RE: 2633 Floral Rd. NW
Grading & Drainage Plan
Engineer's Stamp Date: 08/26/20
Hydrology File: H13D115

Based upon the information provided in your submittal received 09/08/20, the Grading and Drainage Plan is approved for Building Permit and Grading Permit.

2633 FLORAL ROAD, NW GRADING PLAN			
DRAWING:	DRAWN BY:	DATE:	SHEET #
201803-GD.DWG	SH-B	3-6-2018	1

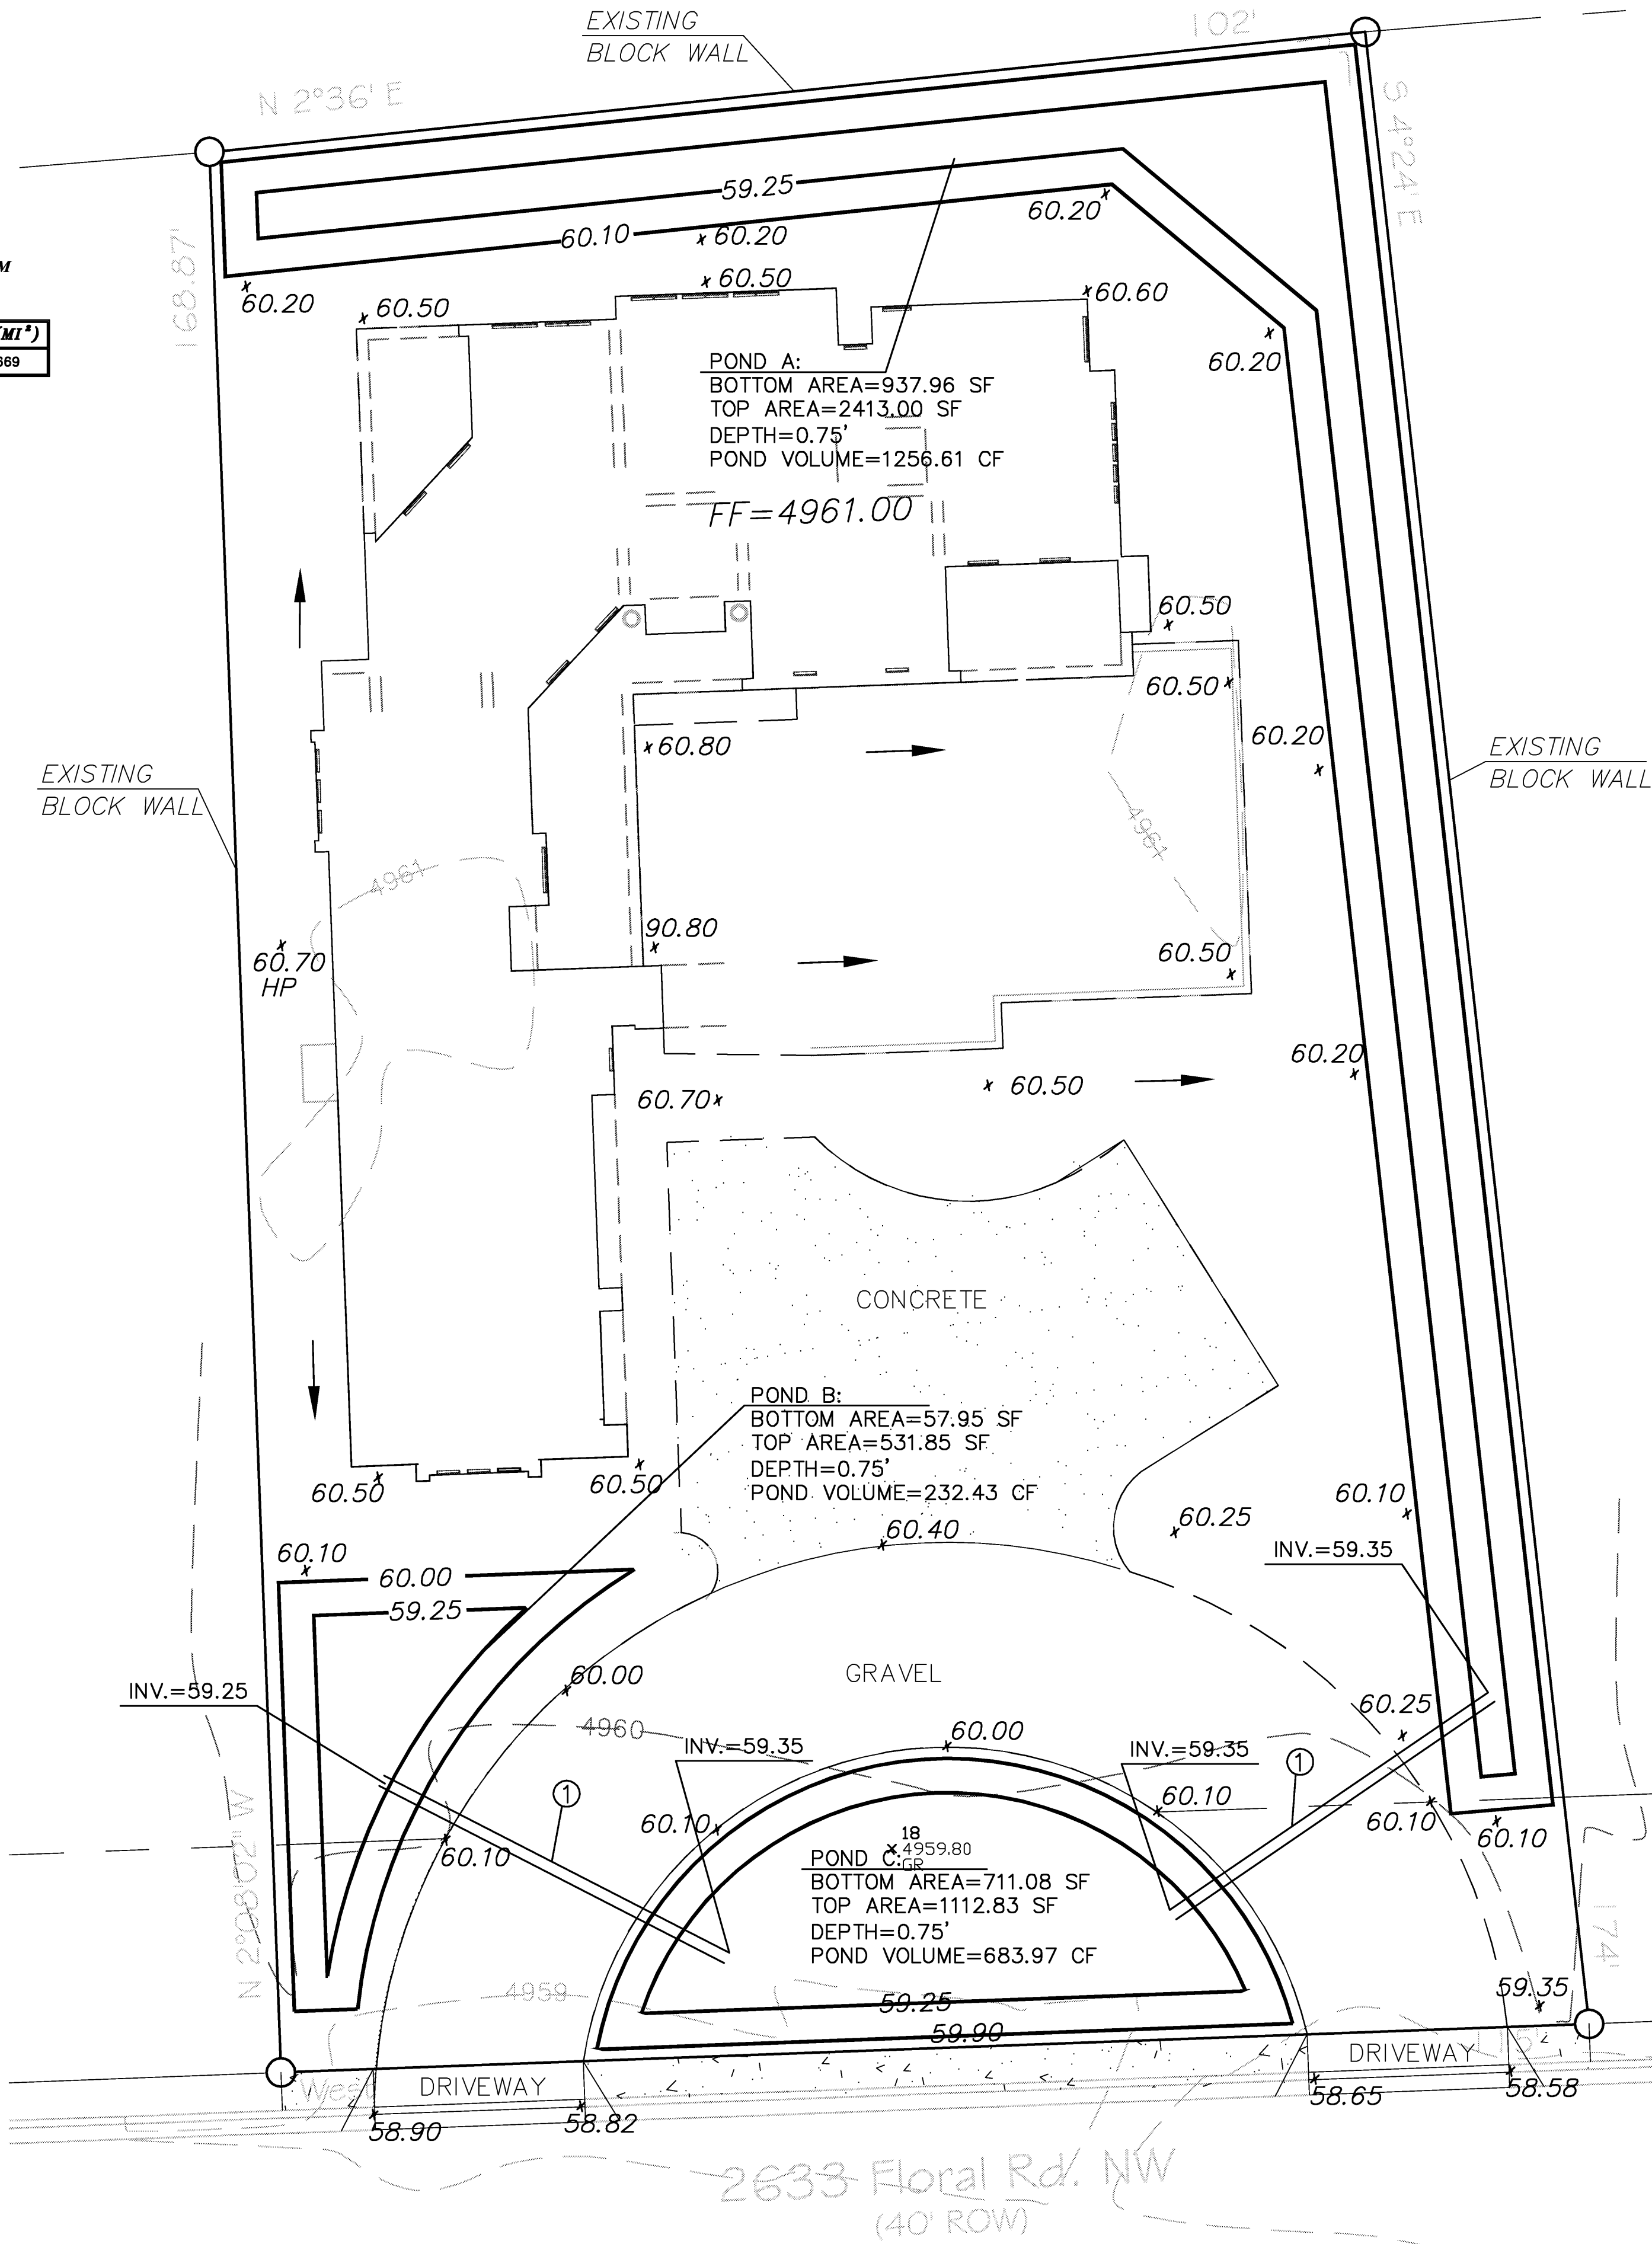
Once the grading is complete, a pad certification will be required prior to release of Building Permit. Please attach a copy of this approved plan in the construction sets for Building Permit processing along with a copy of this letter and the pad certification approval letter.

Prior to approval in support of Permanent Release of Occupancy by Hydrology, Engineer Certification per the DPM checklist will be required.
